MIL-P-17802D
INT. AMENDMENT 3 (ME)
29 September 1980
SUPERSEDING
INT. AMENDMENT 2 (ME)
30 June 1980

MILITARY SPECIFICATION

PADLOCKS AND PADLOCK SETS, LOW SECURITY, KEY

This interim amendment is issued for use by the Mobility Equipment Research and Development Command, Department of the Army, with Military Specification MIL-P-17802D, dated 3 December 1975.

FIGURE 1. Padlock componet nomenclature.

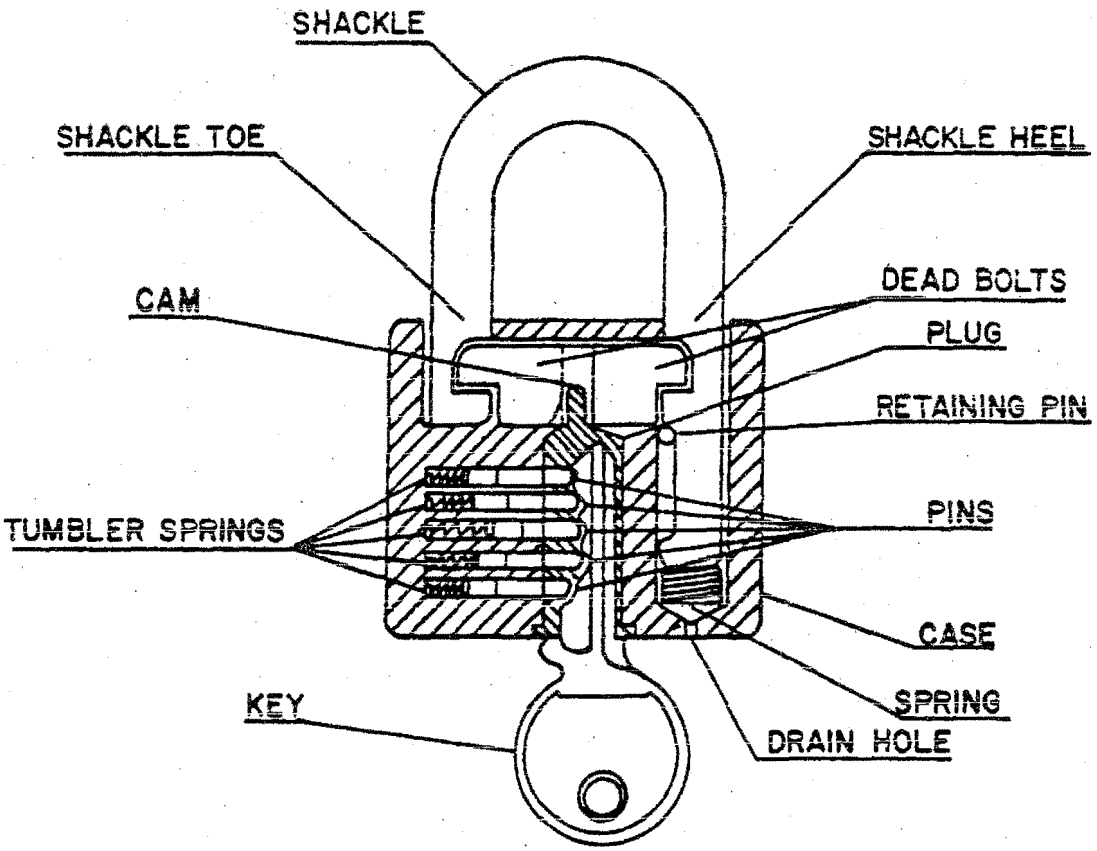
Add the attached Figures 1 thru 4.
